Access Compliance Report

Public Rights-of-Way

(Curb Ramps)

Intersection ID: 6670	Main Street: BELMAR_PLACE_RD	Cross Street: ERNIE_DR	Location: NW
ADA ID: B9B8646CBDDA	Ramp Type: Perp	Initial Pass/Fail: Pass	Overall Compliance: No
		Severity Score: 0.25	
Codes/Mitigation Info/Possible Solution		Field Measurements/Component Compliance

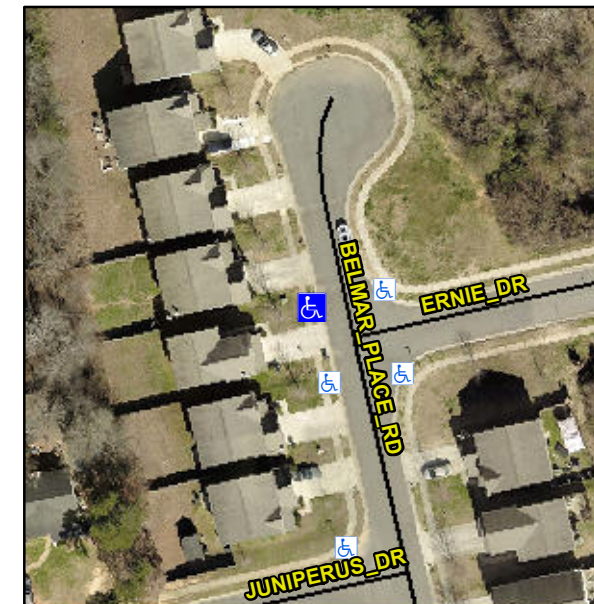
Not Found, R304.2.1, R304.2.2-Perp, R304.3.2-Para, R305.2

Compliance	Description	Data	Compliance	Description	Data
N/A	Ramp Length (in)	48.0	Yes	Ramp Slope (%)	6.2
Yes	Ramp Width (in)	48.0	Yes	Ramp XSlope (%)	3.0
N/A	Flare Type LT	Sloped	N/A	Flare Type RT	N/A
N/A	Flare Slope LT (%)	13.3	N/A	Flare Slope RT (%)	1.1
N/A	Flare Traversable LT?	No	N/A	Flare Traversable RT?	No
No	Landing Length (in)	47.0	Yes	DWS Provided?	Yes
Yes	Landing Width (in)	48.0	Yes	DWS Contrast?	Yes
No	Landing Slope (%)	2.8	Yes	DWS Length (in)	24.0
Yes	Landing X Slope (%)	3.3	Yes	DWS Full Width?	Yes
N/A	Landing Curb? (Y/N)	No	No	DWS Offset (in)	3.0
N/A	Shared Landing?	No			
Yes	Gutter Ponding?	No	Yes	Gutter Slope (%)	4.5
Yes	Gutter Lip Ht (in)	0.0	Yes	Gutter X Slope (%)	3.5
N/A	Painted X Walk1?	No	N/A	Painted X Walk2?	N/A
	X Walk 1 Direction	To E		X Walk 2 Direction	N/A
N/A	X Walk 1 Width (in)	N/A	N/A	X Walk 2 Width (in)	N/A
	X Walk 1 Slope (%)	4.4		X Walk 2 Slope (%)	N/A
	X Walk 1 X Slope (%)	4.2		X Walk 2 X Slope (%)	N/A

N/A	Ramp inside XWalk1?	N/A	N/A	Ramp inside XWalk2?	N/A
	Road Slope (%)	N/A	N/A	Clear Space?	Yes
	Road X Slope (%)	N/A	N/A	Clear Space to XWalk (in)	N/A
Yes	Any Obstructions?	No	Yes	Storm Grate/Utility Hazard?	No
	Obstruction Type			Storm Grate/Utility Type	
		N/A			N/A
			Yes	Surface Condition? (G/P)	Good

Remove & Replace Entire Ramp.
